**RE: Response to Assessment Report**  
**Ppty: Roseville Memorial Club – DA0134/18 | PPS-2018SNH040**

Thank you for the opportunity to provide this response to the Assessment Report dated 10 August 2020 as prepared by Ku-ring-gai Council, scheduled for a Sydney North Planning Panel (SNPP) teleconference on September 2, 2020.

**RE: Response to Assessment Report**  
**PPty: Roseville Memorial Club – DA0134/18 | PPS-2018SNH040**

DRAWING TITLE:  
**BASEMENT 3 PLAN**

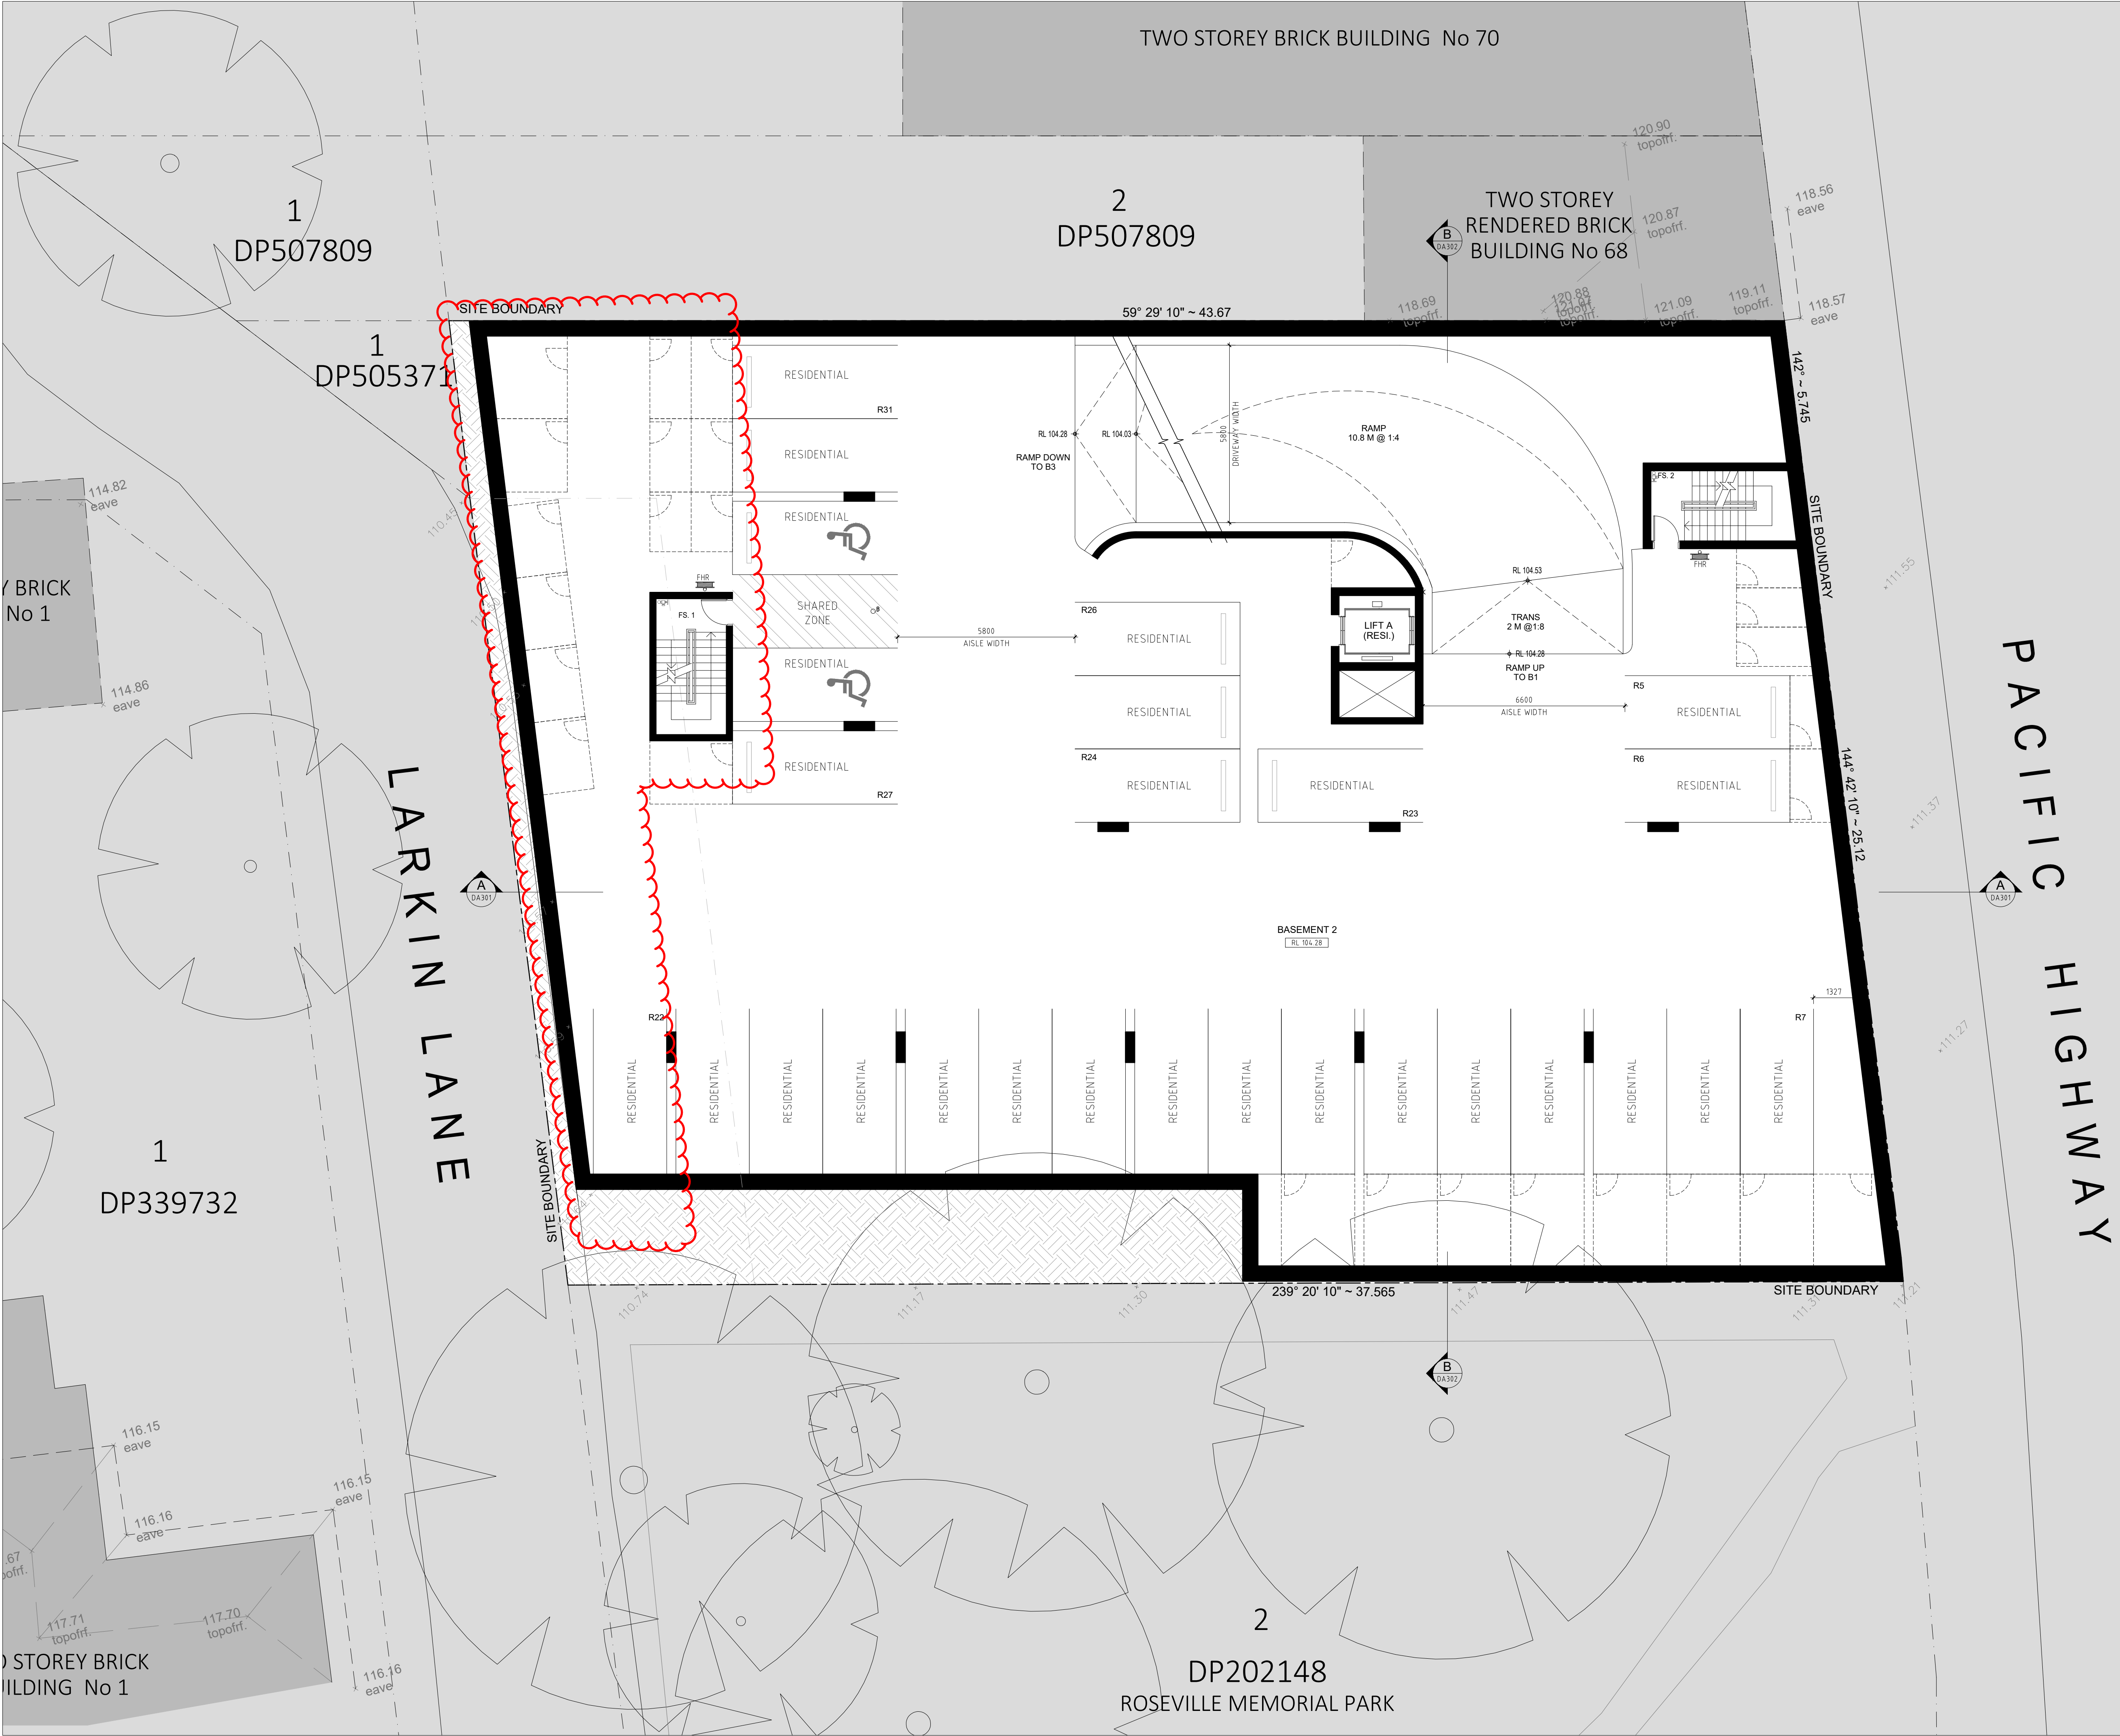
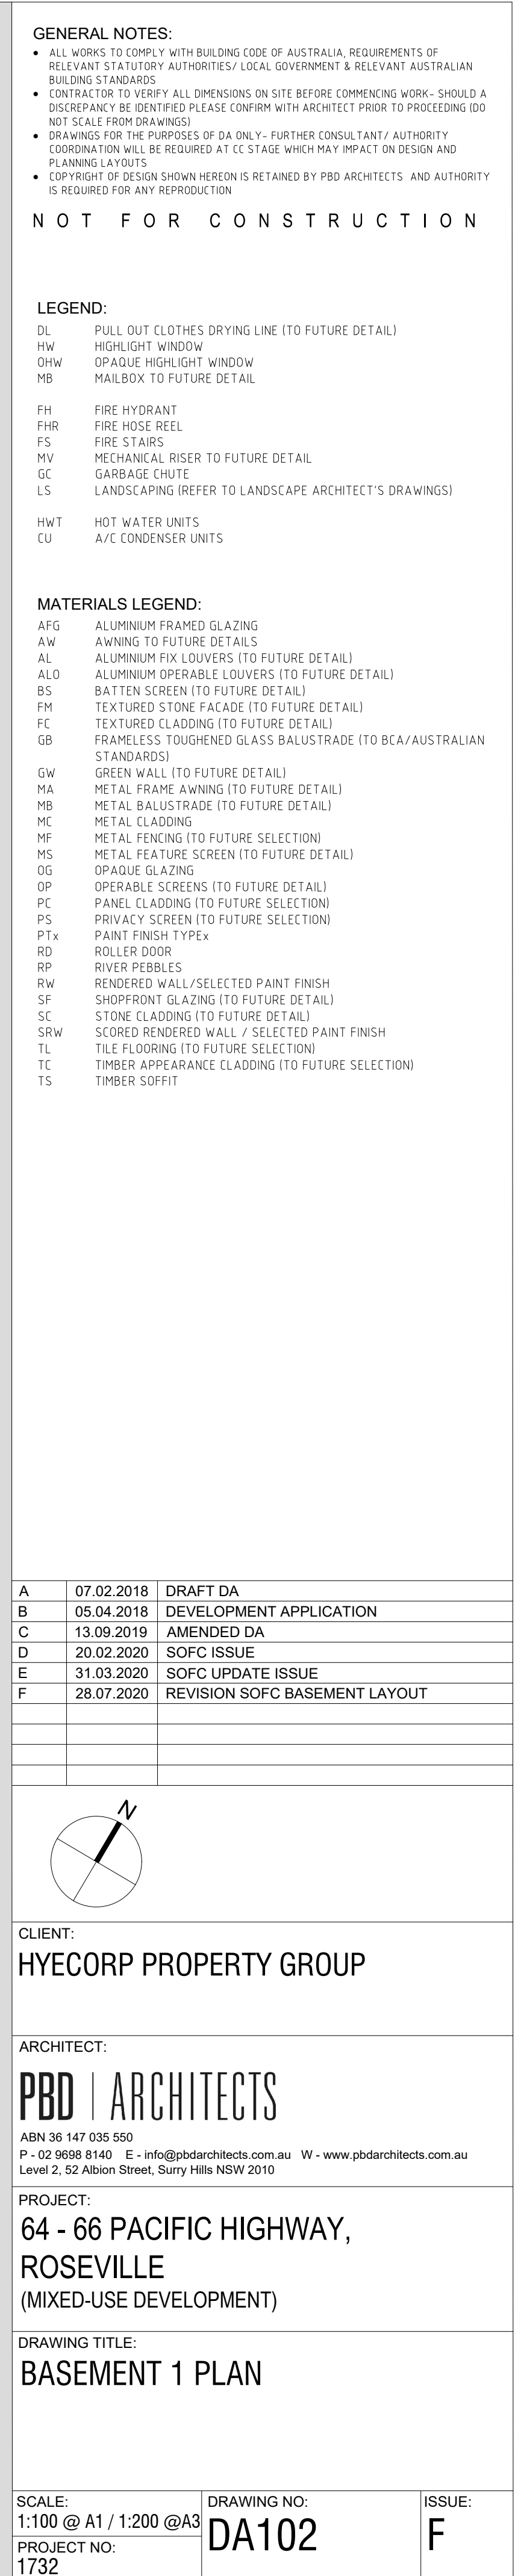
The attached plans, which show an amended basement plan, increase the number of basement spaces allocated to the club to 11.

The submitted plans are a direct reflection of basement design development which has allowed the provision of an additional parking space to the memorial club.

## **Appendix 3 – Active Street Frontage**

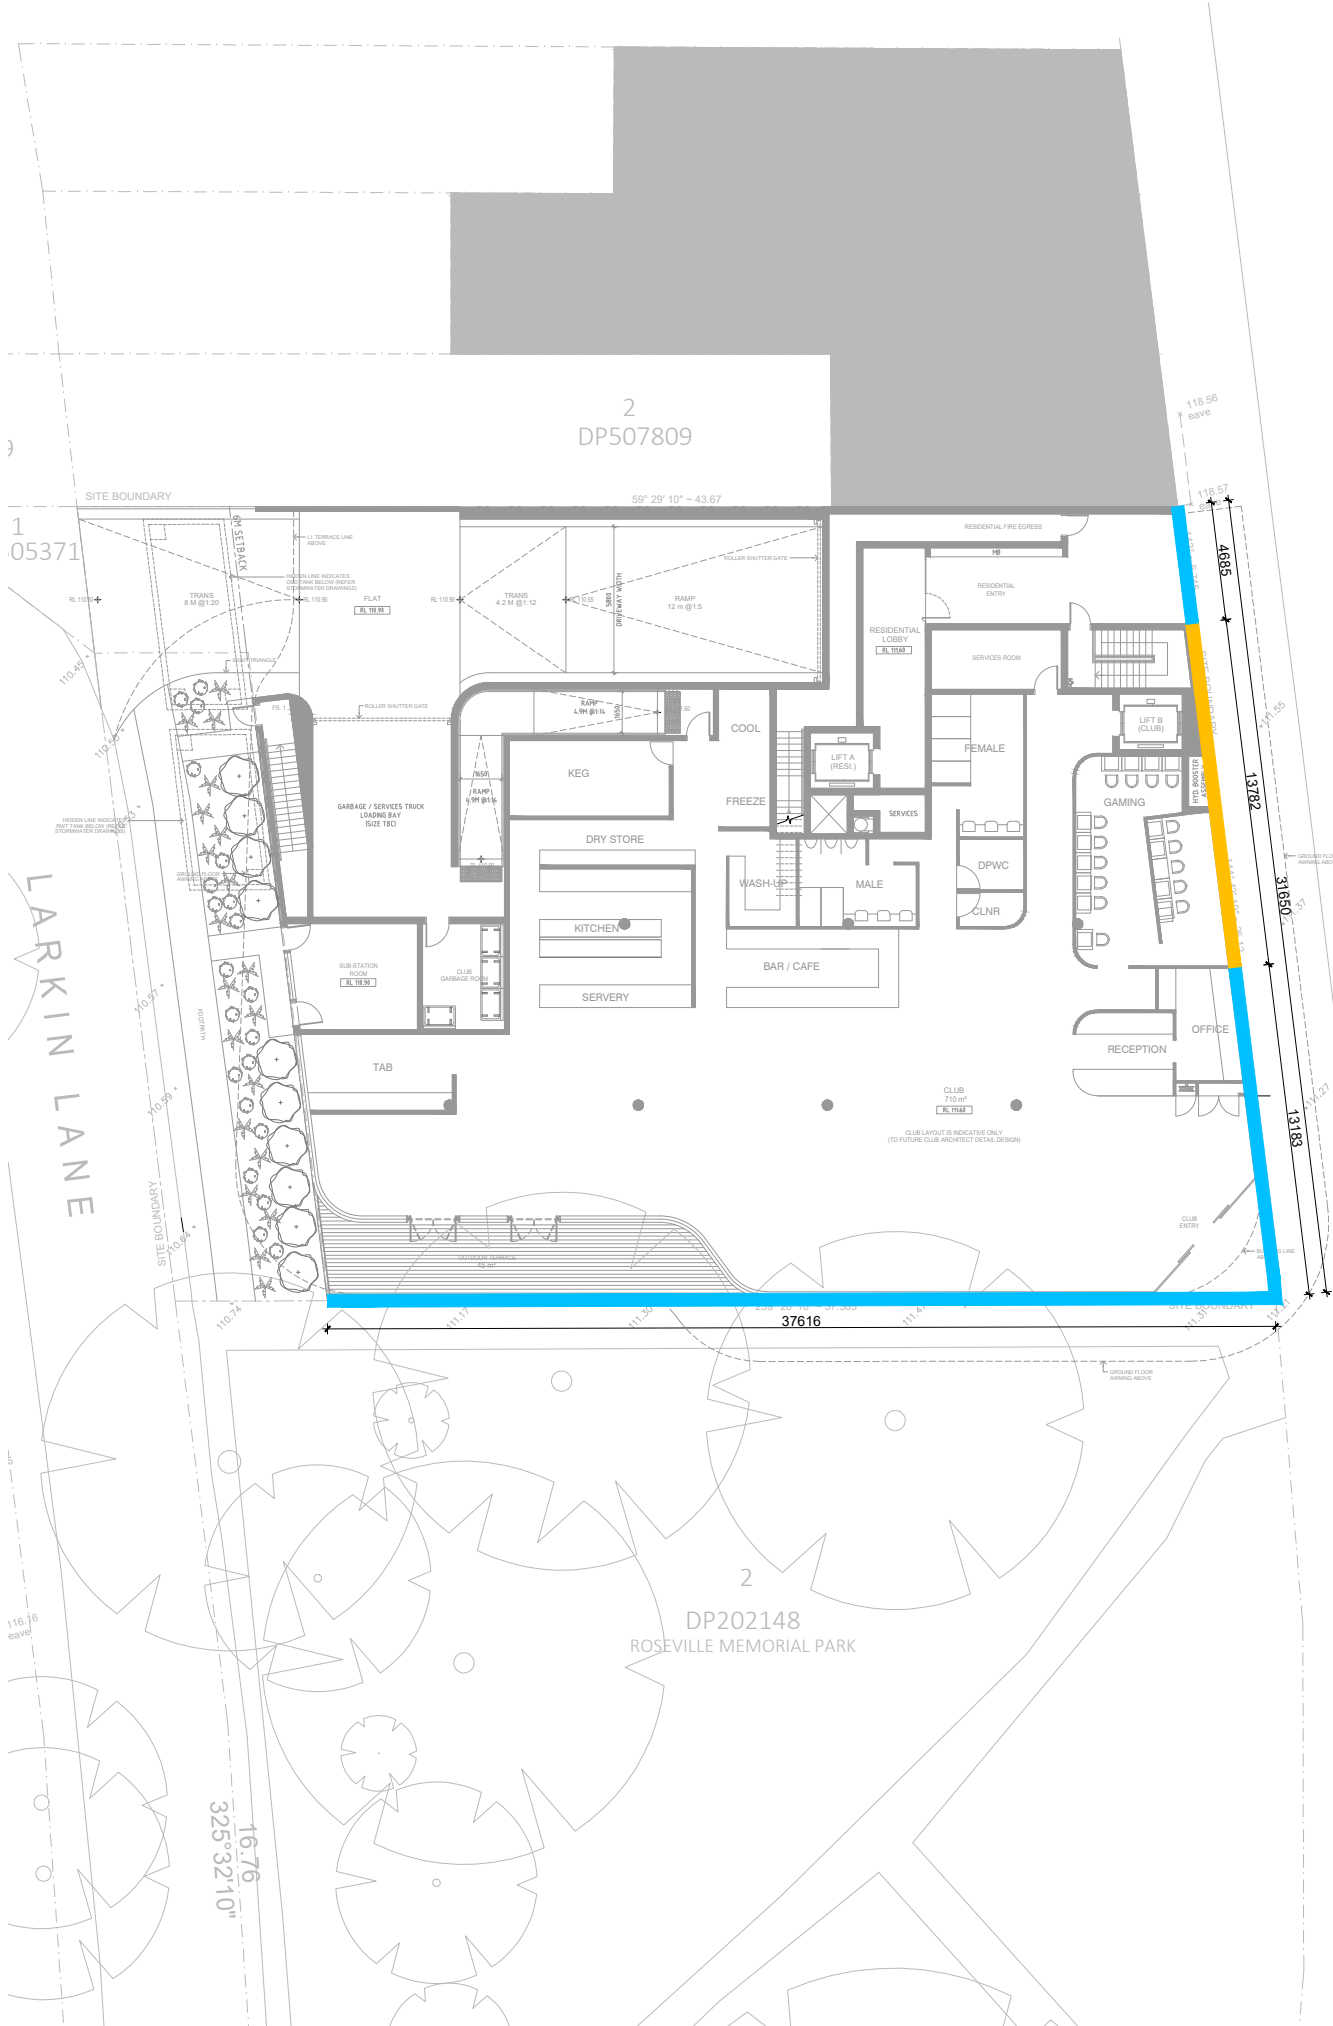
- The relevant clause of the DCP, Section B, Part 14F.9, 7(iii) specifies: *“Provide active street frontages along the Pacific Highway and the frontage to Memorial Park.”*
- A revised Plan, prepared by PBD Architects can be found in **Appendix 3** which shows a total active street frontage in accordance with the DCP of 80% along Pacific Hwy and Memorial Park.
- In our proposal, the ground floor use, being a Club, actively opens onto the park and addresses the corner of the park and Pacific Highway. An outdoor terrace is provided in the southern corner overlooking the park and wrapping around to Larkin Lane.
